HISTORIC AND DESIGN REVIEW COMMISSION

March 01, 2017

HDRC CASE NO: 2017-081
ADDRESS: 431 HAYS ST
LEGAL DESCRIPTION: NCB 528 BLK 1 LOT E 16.7 FT OF 15 & E 53.06 FT OF 16
ZONING: R-5
CITY COUNCIL DIST.: 2
DISTRICT: Dignowity Hill Historic District
APPLICANT: David Hope
OWNER: David Hope
TYPE OF WORK: Driveway
REQUEST:

The applicant is requesting a Certificate of Appropriateness for approval to install an 11 foot wide driveway and add a 14' x 27' concrete driveway beneath the existing carport.

PLOT PLAN

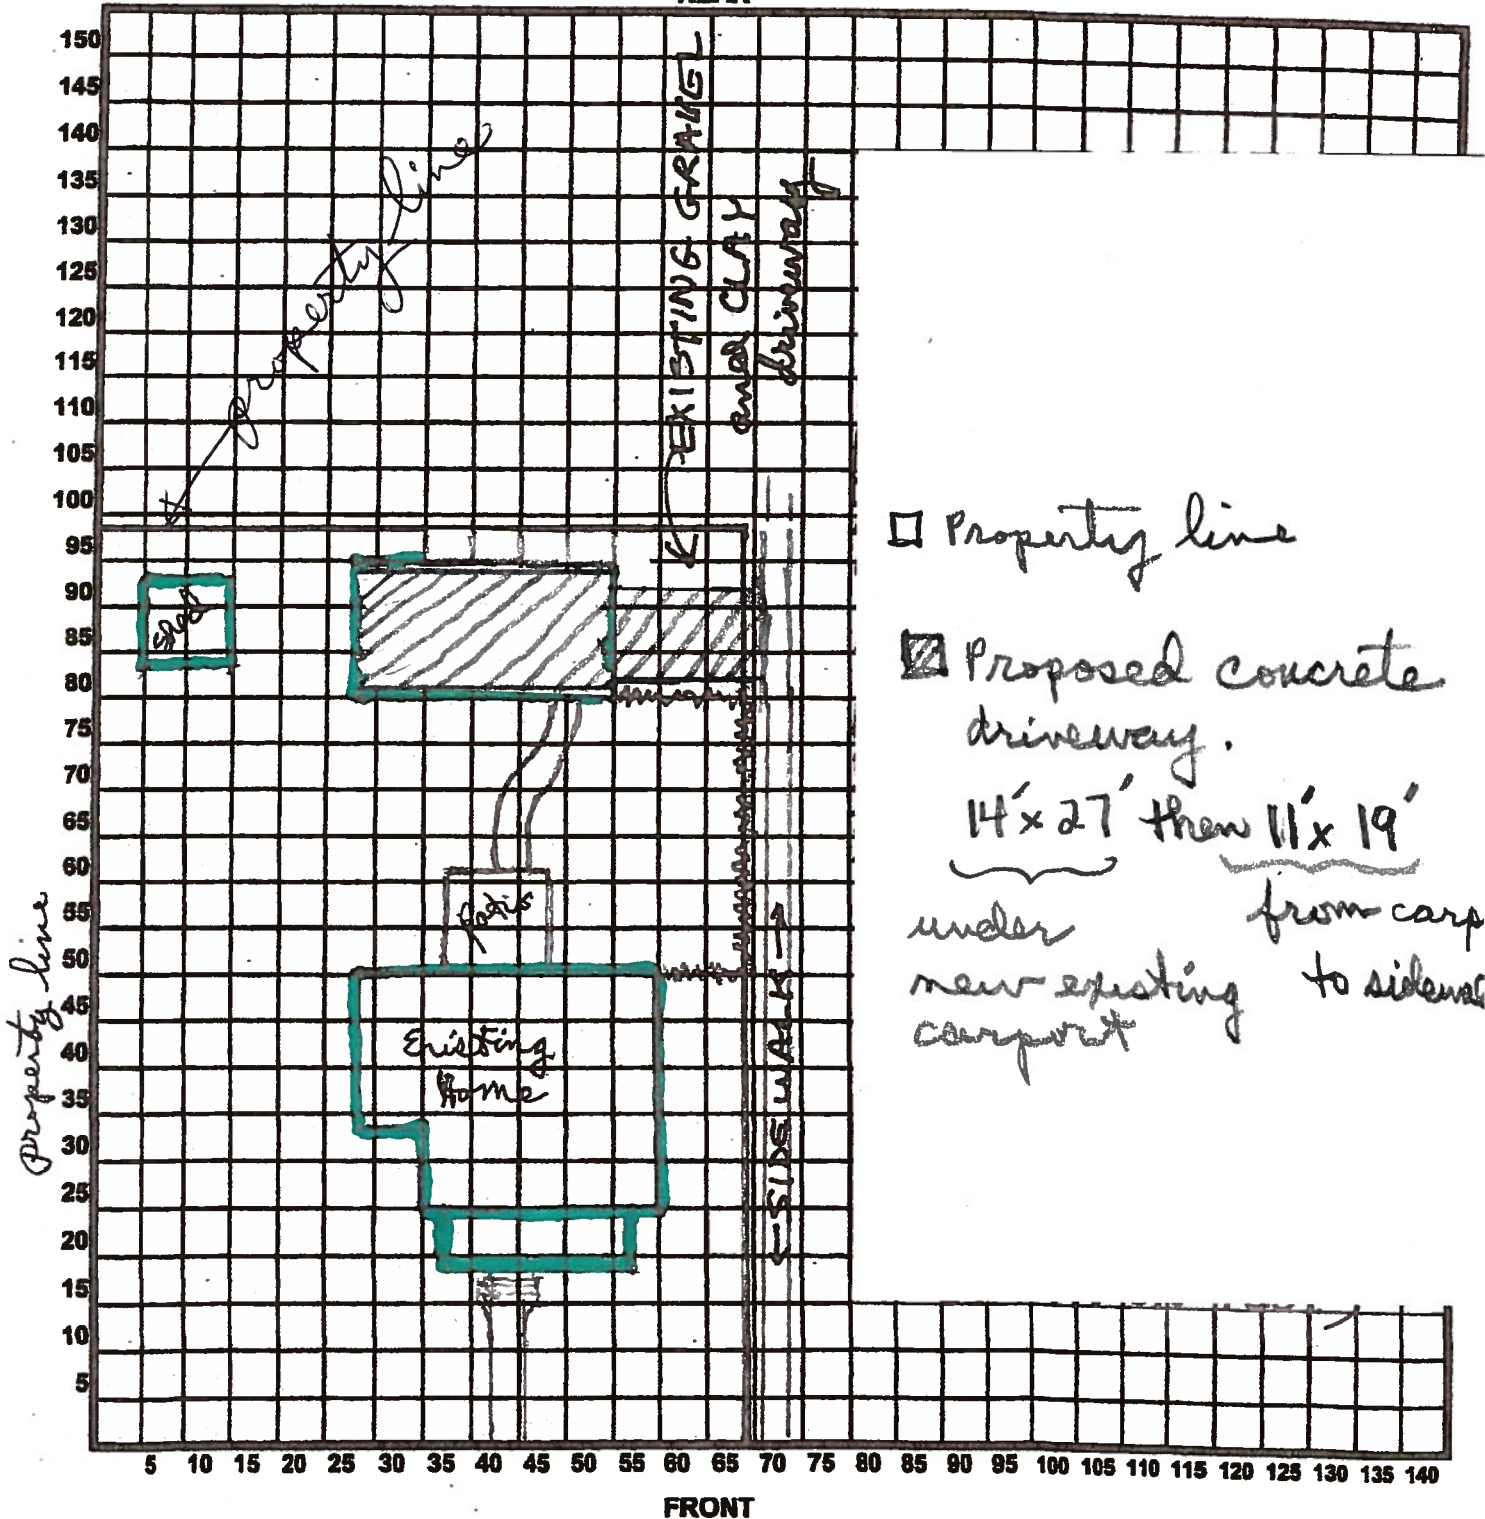
- a. The main structure at 431 Hays St, a corner lot, is a folk Victorian two story home with wood siding, front facing gable, rear hipped roof with standing seam metal. There is a rear newly constructed carport at the rear of the property that is accessed by an existing curb cut along N Mesquite
- b. There is an existing curb cut made of asphalt. The proposed driveway will be made of concrete will extend from the existing sidewalk to the edge of the existing carport at 11' wide. It will widen to 14' underneath the existing carport. According to the Guidelines for Site Elements 5.B., new driveways should be constructed where they would historically be found on the site. Historic driveways are typically no wider than 10 feet. Staff finds the proposed driveway appropriate, but finds that 10' in width would be appropriate.

Staff recommends approval based on findings a and b with the stipulation that the driveway width is 10'.
